Our Ref: R/2024/4
File No: 2024/308631
Your Ref: SSD-67588459

SSD-67588459 – Environmental Impact Statement – Powerhouse Ultimo Revitalisation

Figure 1. Extract from architectural plans (Appendix B)

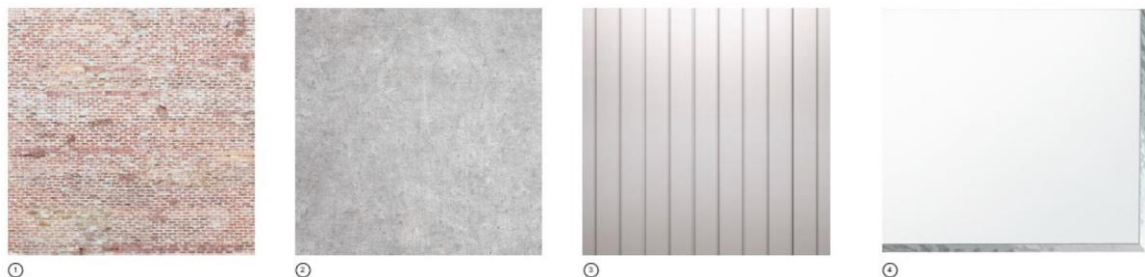
There is only a very limited palette of materials shown on the architectural drawing set:

The proposed materials and finishes need to be further clarified and the drawings should be amended to clarify materials and key these to the elevations and sections. This is also requested to assist in assessing the potential heritage impacts of the additions.

Figure 2. Extract from architectural design report (Appendix E)

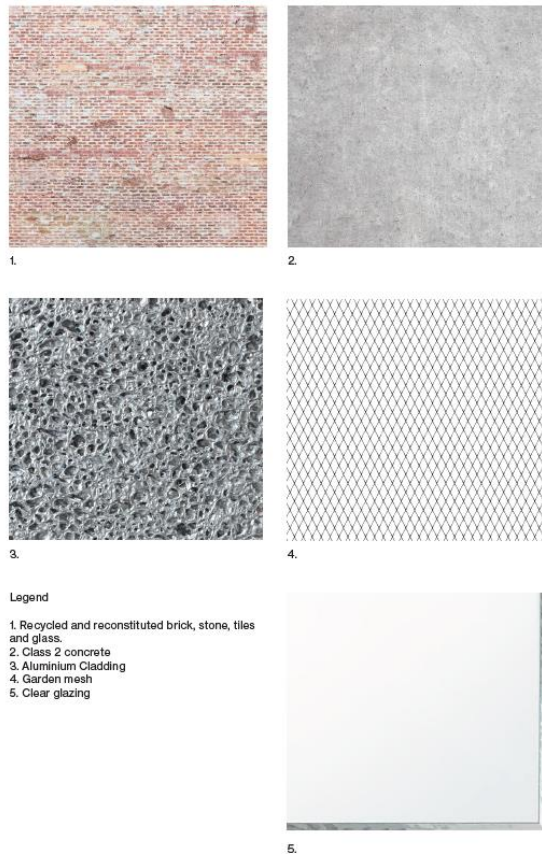
The design report also includes garden mesh and aluminium cladding

The design report also references *'The new built form will be comprised of a mix of recycled and new bricks, brick slips, stone, ceramics, glass, metal cladding and class 2 in situ concrete and precast concrete.'*
